09 - 2011
BDF454 / BDF454Z / BDF454F
18V 1/2" CORDLESS DRIVER DRILL

SERVICE CHANGES

1. Changes on Switch, Terminal, and Housing Set (Battery Protection Circuit)

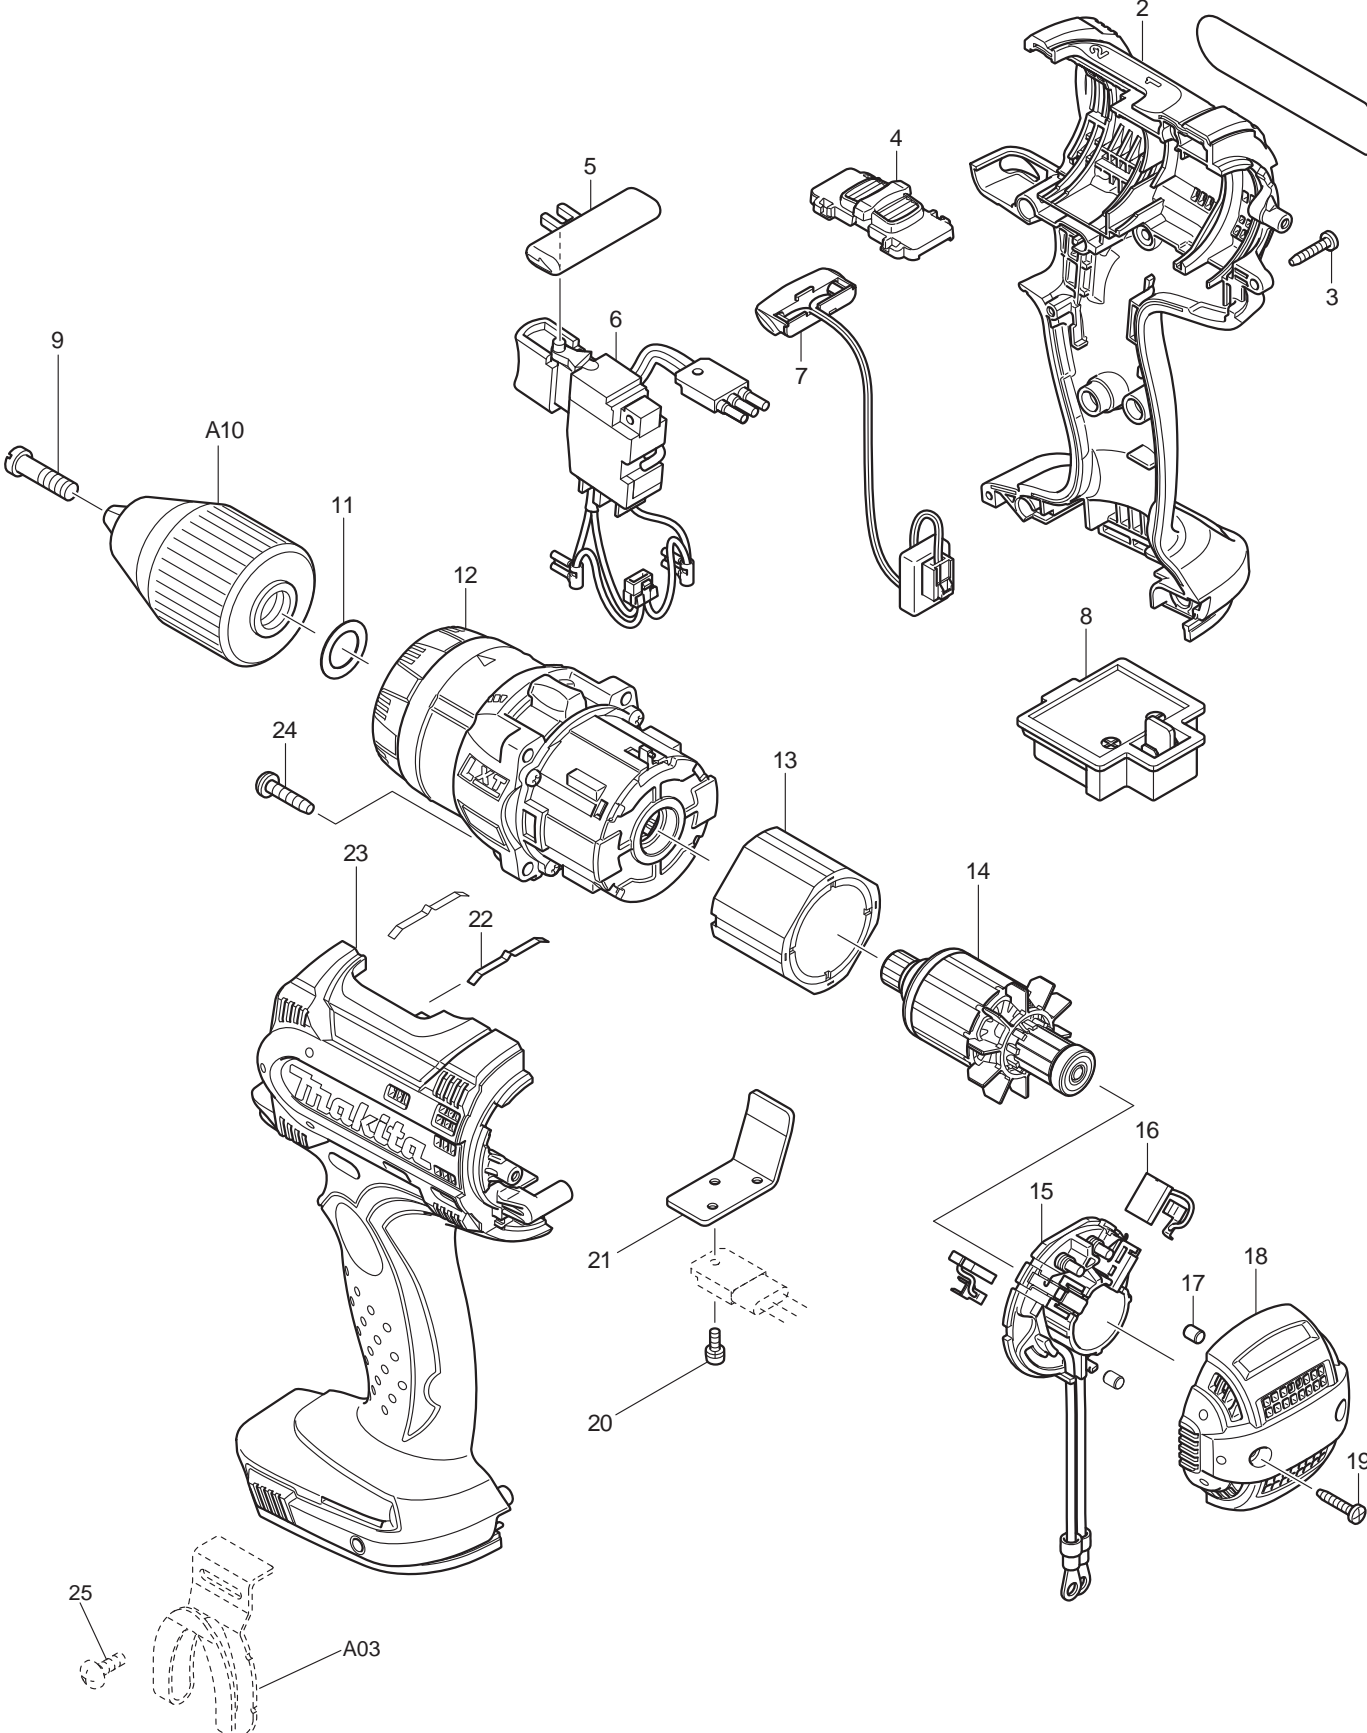
Item No.	Description	Type 1	Type 2	Type 3
2	HOUSING SET		188525-5	187356-9
6	SWITCH		650573-9	650693-9
8	TERMINAL	643812-4	643838-6	643859-8

Above parts are completely interchangeable as a set.

- Use new parts for repair of the model manufactured on or after March 2012 with using Yellow lead wire between Switch and Terminal.
- Use current parts for repair of the model manufactured before March 2012 without using Yellow lead wire between Switch and Terminal.
